THE CITY OF SAN DIEGO

ADDENDUM TO A ENVIRONMENTAL IMPACT REPORT

Project No. 516820
Addendum to EIR No. 233958
SCH No.: 2011031074

SUBJECT: **BALBOA PARK PLAZA DE PANAMA PROJECT:** The following approvals are being requested in association with the project: AUTHORIZE A COOPERATION AGREEMENT BETWEEN THE CITY AND THE PLAZA DE PANAMA COMMITTEE, AUTHORIZE THE MAYOR TO AWARD A CONSTRUCTION CONTRACT FOR THE PROJECT, and AUTHORIZE FUNDING for Project. The Plaza de Panama Project, as previously approved proposes to remove vehicular access and parking from the Plaza de Panama, El Prado, Plaza de California, the Mall, and Pan American Road East and allow these areas to be used by pedestrians only. A new bridge, "Centennial Bridge," would connect the eastern end of Cabrillo Bridge to the western side of the Alcazar parking lot. From that point a new "Centennial Road" would traverse through the Alcazar parking lot exiting to the east, continue to the south past a new Organ Pavilion parking structure and then connect to Presidents Way. Additional parkland would be provided atop the new parking structure. A tram would provide service from the parking structure to the Plaza de Panama with possi

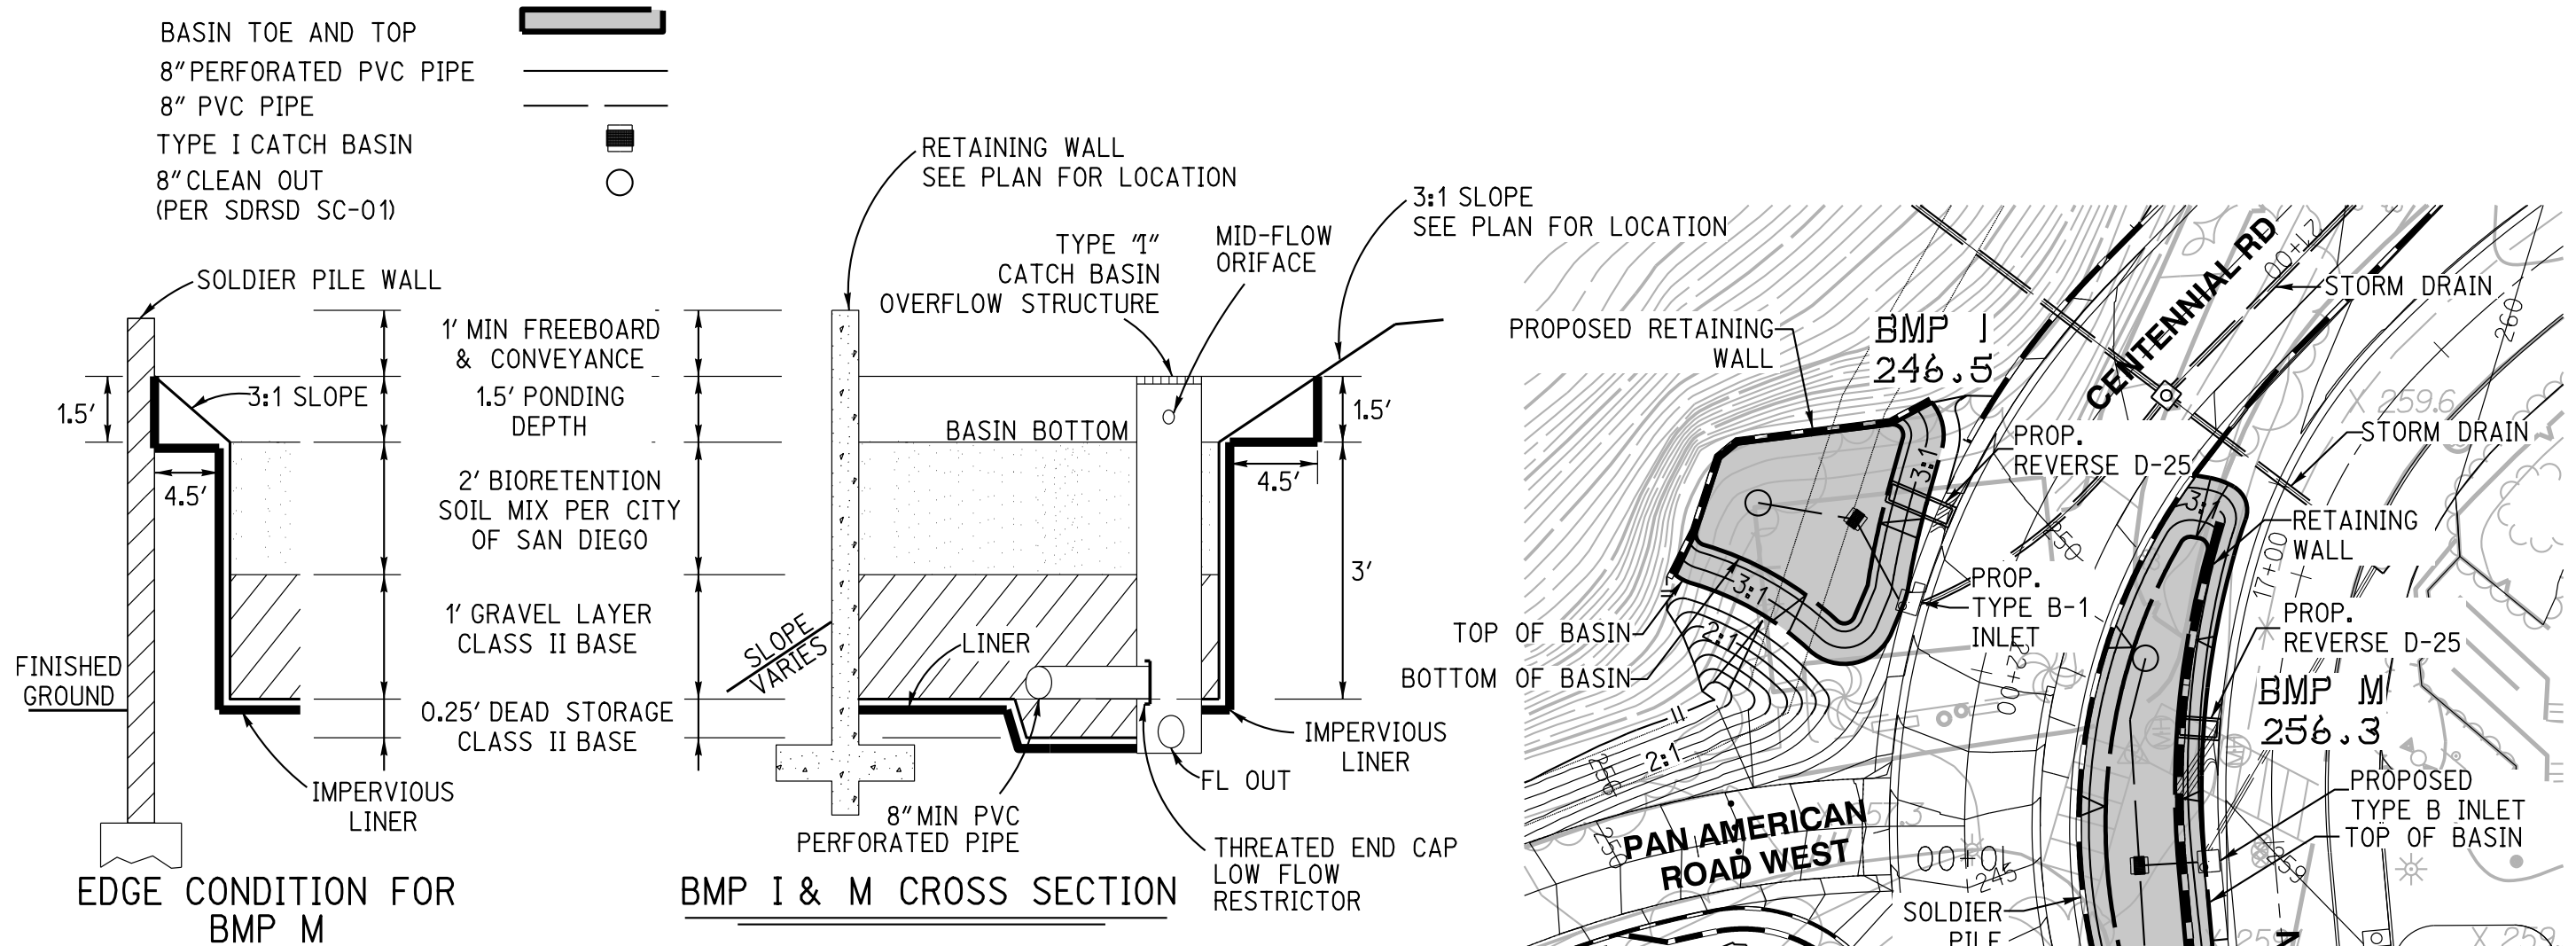
- **BMPs B & E** – These two basins would be co-located within the slope along the southwestern corner of the Alcazar parking lot (Figure 3). The current design would incorporate the BMPs into the existing retaining wall system identified in the 2012 EIR. The footings of the retaining walls would be buried and the walls would have a maximum exposure of 3.5 feet, which would be partially screened by existing vegetation. In any event, the 2012 project also included basins with smaller surface area and volume at this site that had retaining walls extending aboveground from 1-4 feet, so the change in the views of the retaining wall from the canyon is minimal or non-existent. Moreover, the retaining wall extending from BMP B to the Centennial Bridge as disclosed in the 2012 EIR is up to 15 feet high, and was not deemed a significant visual impact. The two retaining walls would be visible from the archery range canyon, Palm Canyon, and the International Cottages. The walls would not be visible from the Alcazar parking lot. The bottom of these basins would consist of soil that would be vegetated. The interior walls of the basins would extend above the basin bottoms by no more than 2.5 feet and would be partially screened by the grasses and bushes planted in the basin bottoms.

NOTE: BMP B HAS AN AVERAGE HEIGHT OF RETAINING WALL OF 6.5' AND 7.5'. BMP E HAS AN AVERAGE WALL HEIGHT OF 6.5'.

FIGURE 4
BMPs I & M

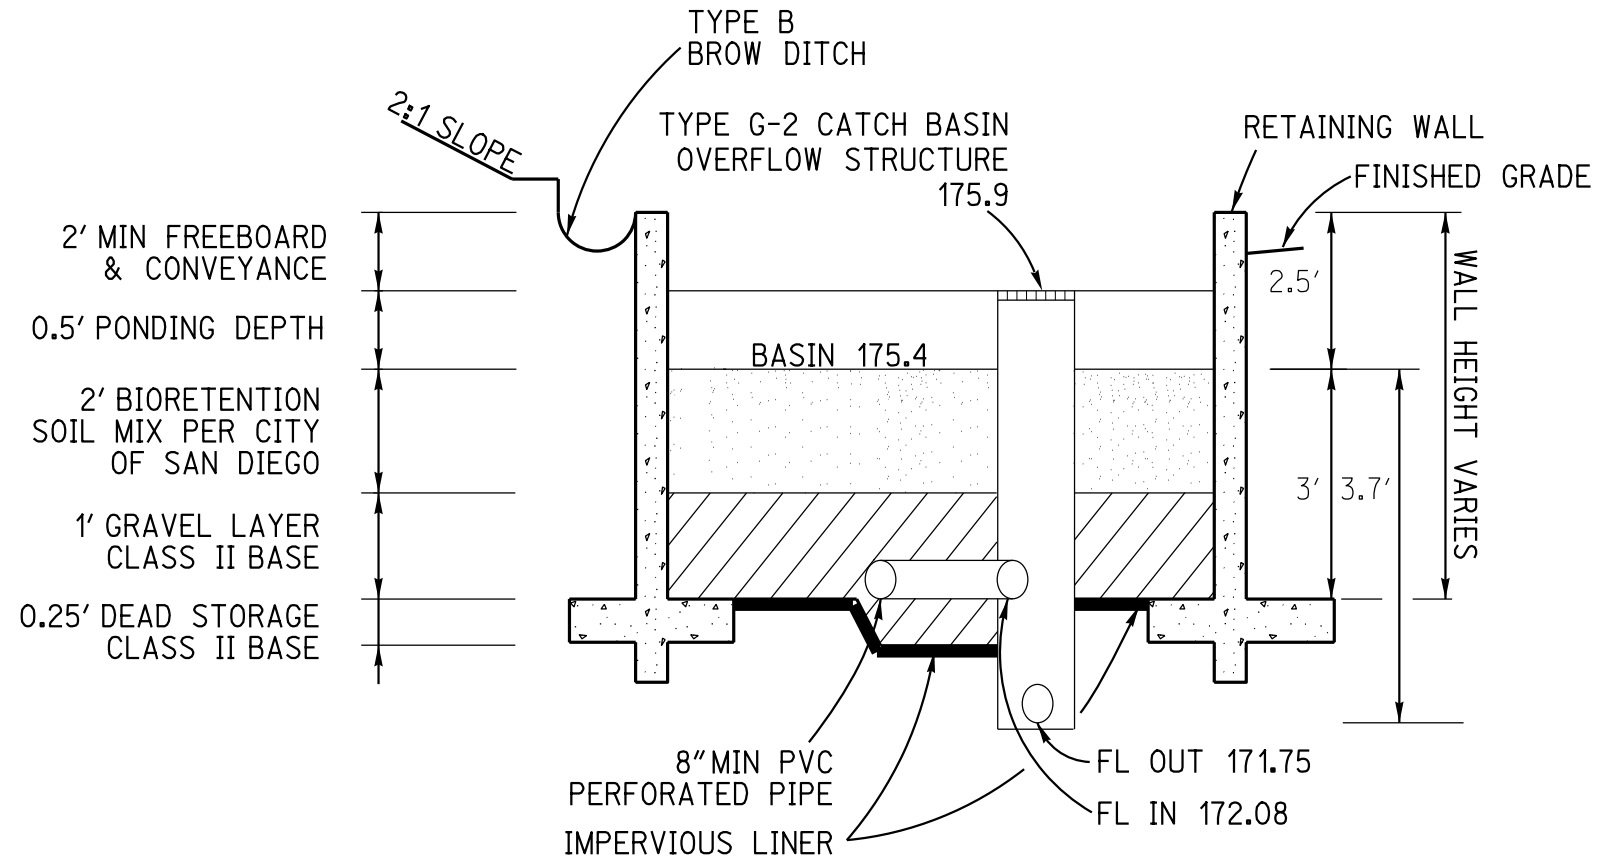
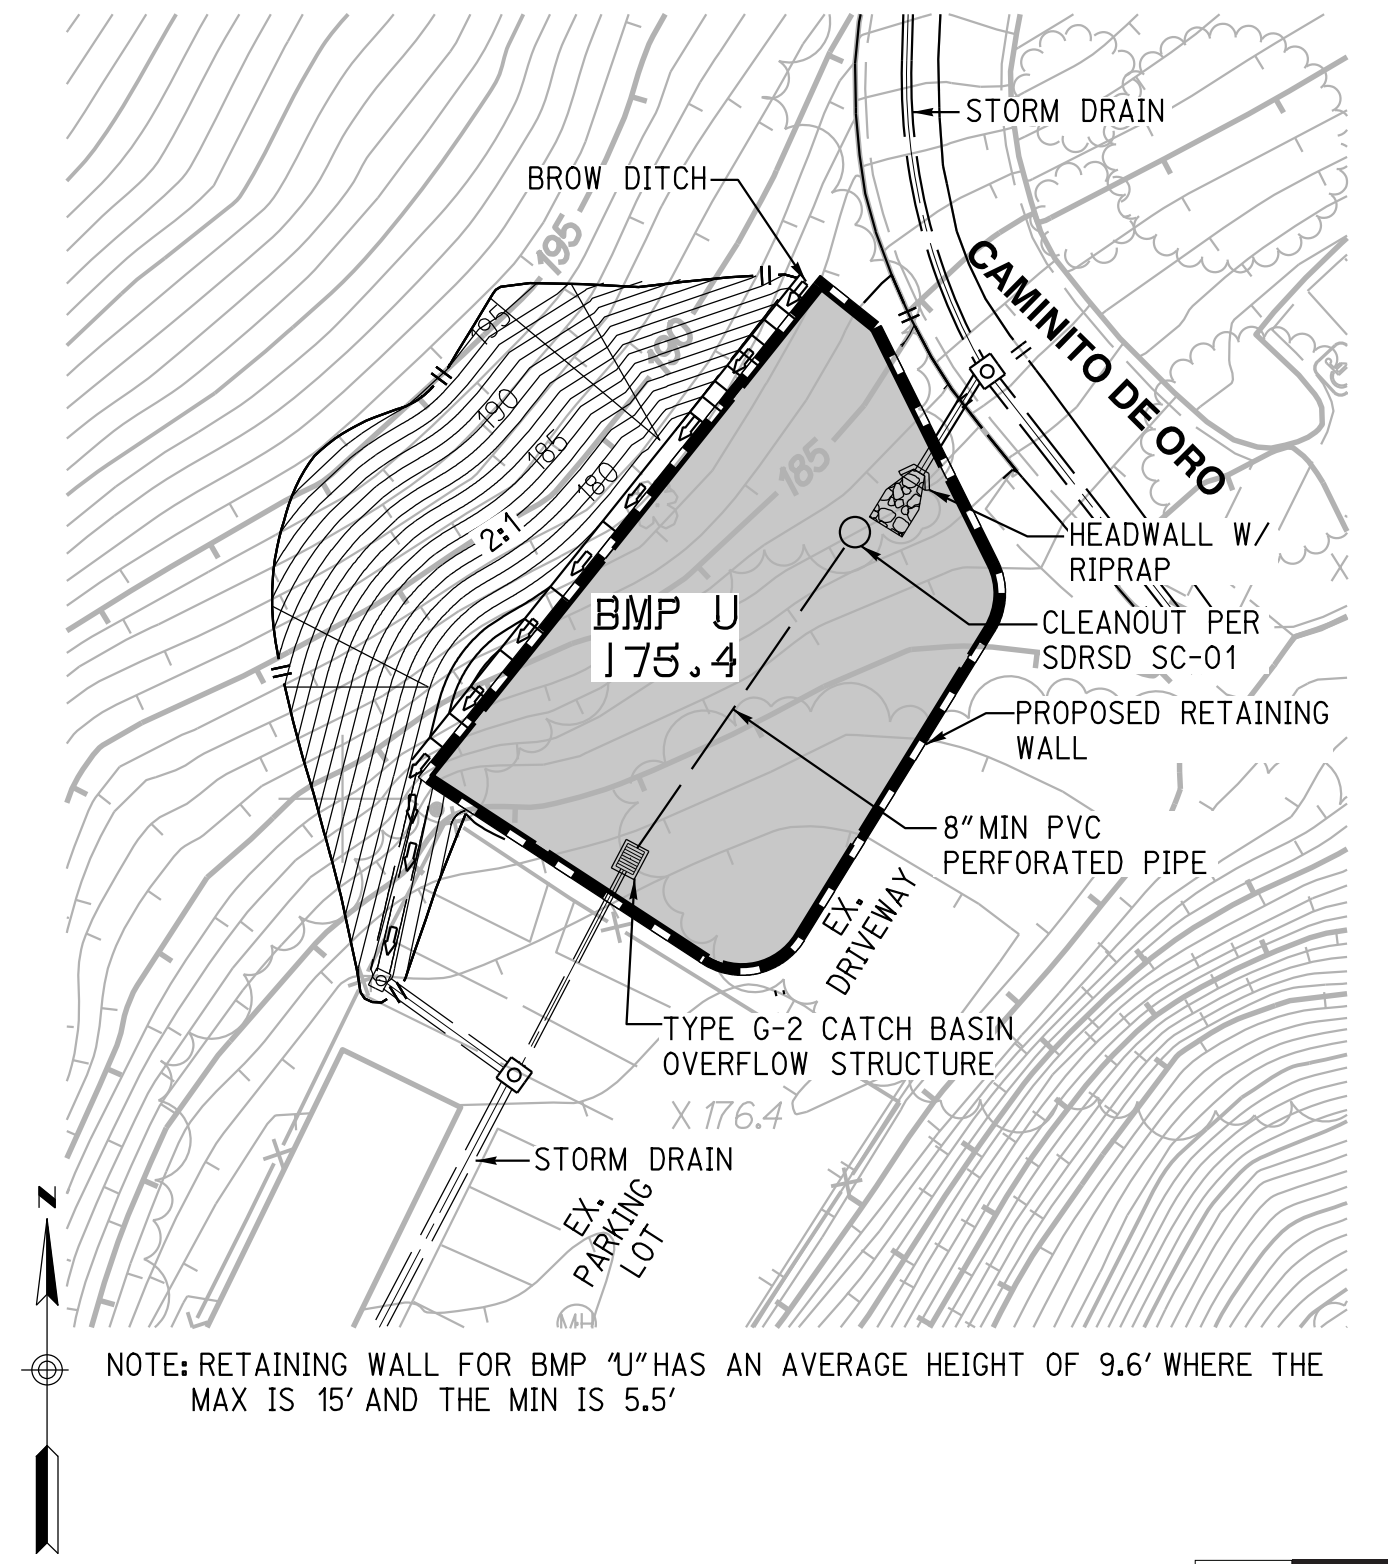
- **BMPs I & M** – These two basins (Figure 4) would be located near the existing restroom (proposed for demolition) at the intersection of Pan American Road West and Centennial Road. BMP I would be lower than the grade of the proposed Centennial Road, would be vegetated, and would be minimally visible from the road. From Palm Canyon, BMP I would be at a higher elevation than pedestrians traversing the canyon, but almost directly beneath the Palm Canyon Walkway. There would be a retaining wall associated with this BMP. The majority of the retaining wall would be below grade, and the maximum exposure would be 2 feet (at the south corner which does not face Palm Canyon). The maximum exposure of the portion which faces Palm Canyon would be approximately 6 inches. Palm Canyon is heavily vegetated and the portions impacted by construction would be re-vegetated pursuant to the landscaping plan, so any views from the canyon would be screened. The retaining wall in the interior of the basin would extend no more than 1.5 feet above the

NOTE: RETAINING WALL FOR BMP "I" HAS AN AVERAGE HEIGHT OF 7.25' WHERE THE MAX IS 9' AND THE MIN IS 5.5'

RETAINING WALL FOR BMP "M" HAS AN AVERAGE HEIGHT OF 5' ACROSS FULL LENGTH OF THE WALL

FIGURE 5
BMP U

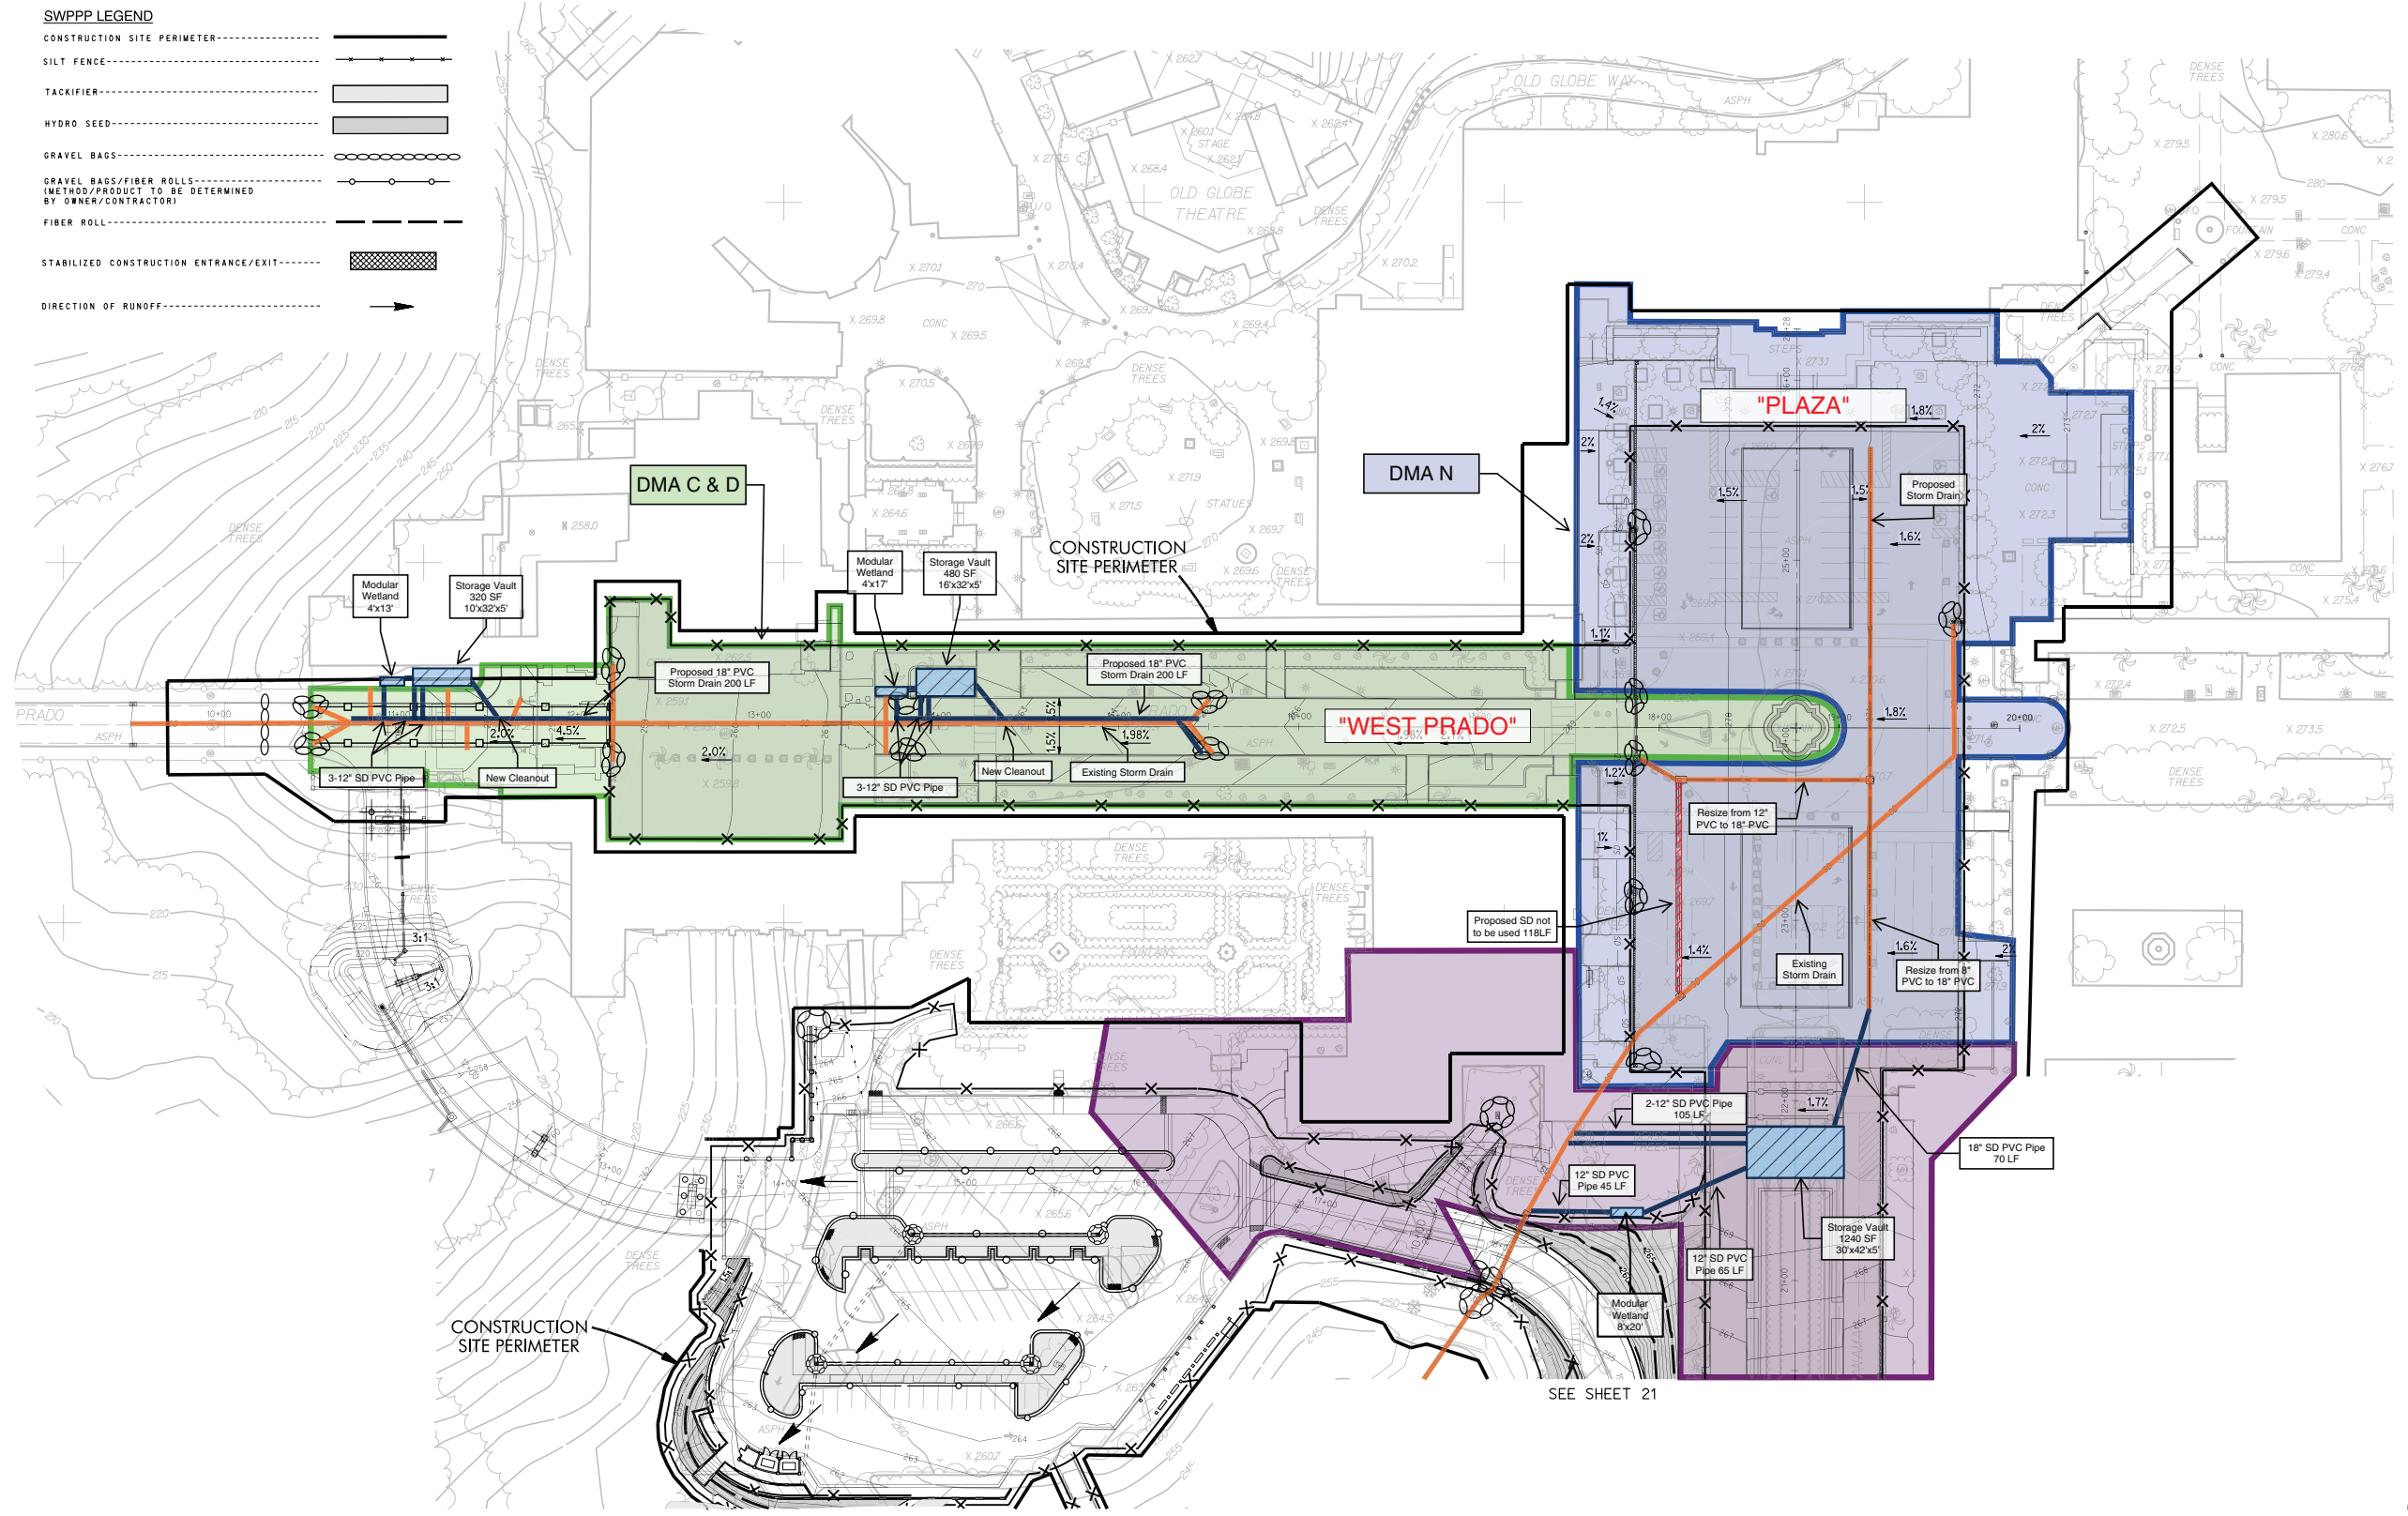
- **BMP U** – This basin (Figure 5) would be located within an off-site improvement area located within a previously disturbed area in Gold Gulch, adjacent to Caminito de Oro and inside the fenced Park and Recreation Department maintenance yard (tram yard). This improvement would be the only BMP located outside the grading footprint of the 2012 project.
